City of Portland, Maine - Building or Use Permit Application

Permit No: 08-1302	Issue Date: 11/13/08	CBL: 401 A014001
-----------------------	-------------------------	---------------------

Location of Construction: 401 ALLEN AVE	Owner Name: BRADFORD ALLEN E JR & WHI	Owner Address: 24 WOODMERE RD	Phone:
Business Name:	Contractor Name: Fortin Construction Inc	Contractor Address: 35 Markarlynn St Auburn	Phone: 2077868737
Lessee/Buyer's Name	Phone:	Permit Type: Single Family	Zone: R-3

Proposed Use: Single Family Home - Stick build 30' x 34' Colonial w/ 23' x 24' attached garage	Proposed Project Description: Single Family Home - Stick build 30' x 34' Colonial w/ 23' x 24' attached garage
--	--

**Garage
Cross Section**

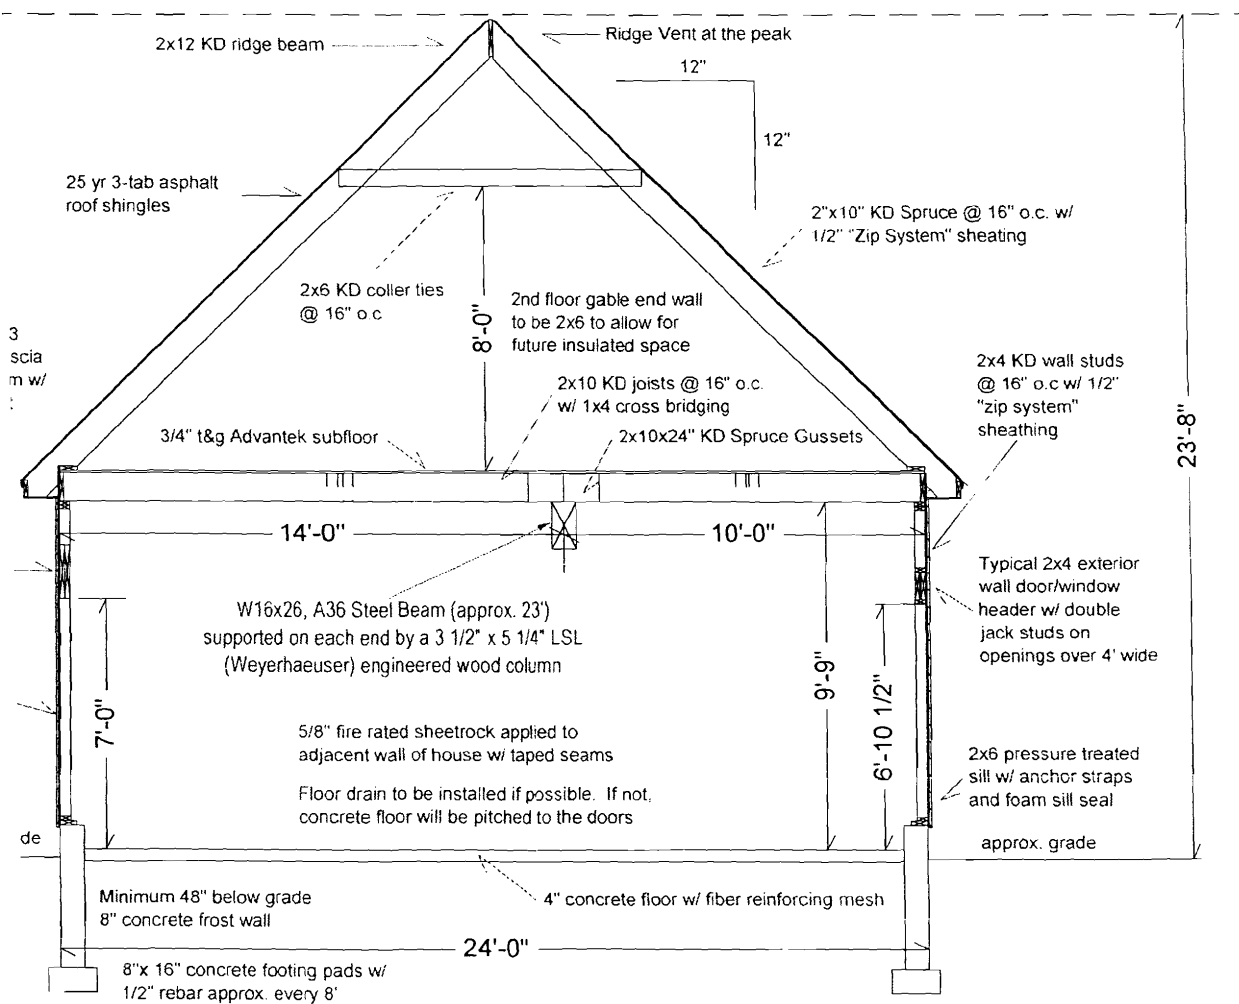
- ✓ 1. Survey letter confirming bldg. loc.
(sides 14.5 / 14 min.)
2. 2006 - Letter from eng. - should be
2003 - IRC. revise.
3. No floor drain - pitch floor
4. Attic access 22x30 R 807
5. WRAP Steel beam w/ 5/8" sheetrock ✓
6. Garage walls 1/2" sheetrock
7. uplift connectors on trusses req. ✓

Exterior Deck/Step Detail w/ Railings**Fire Separation Detail
(not to scale)**

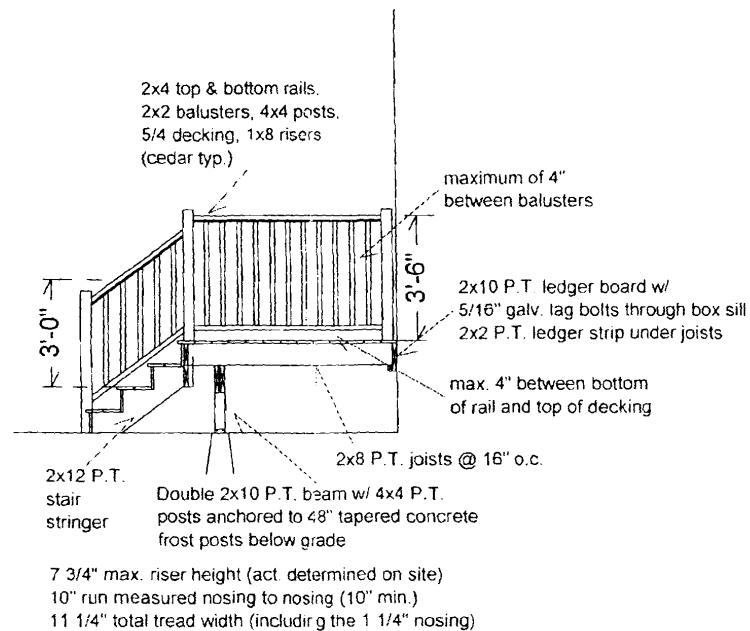
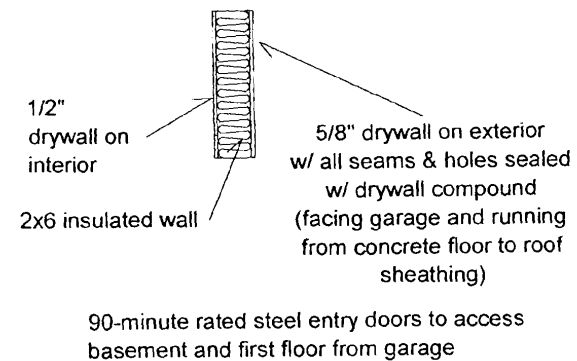
- 10) Uplift connectors required per manufacturers installation requirements
- 11) Steel beam must be protected in garage w/ 5/8" sheetrock
- 12) The owner and builder agree to submit a statement from a licensed surveyor PRIOR to placement of backfill stating the location of the structure is compliant with the City of Portland required setbacks.
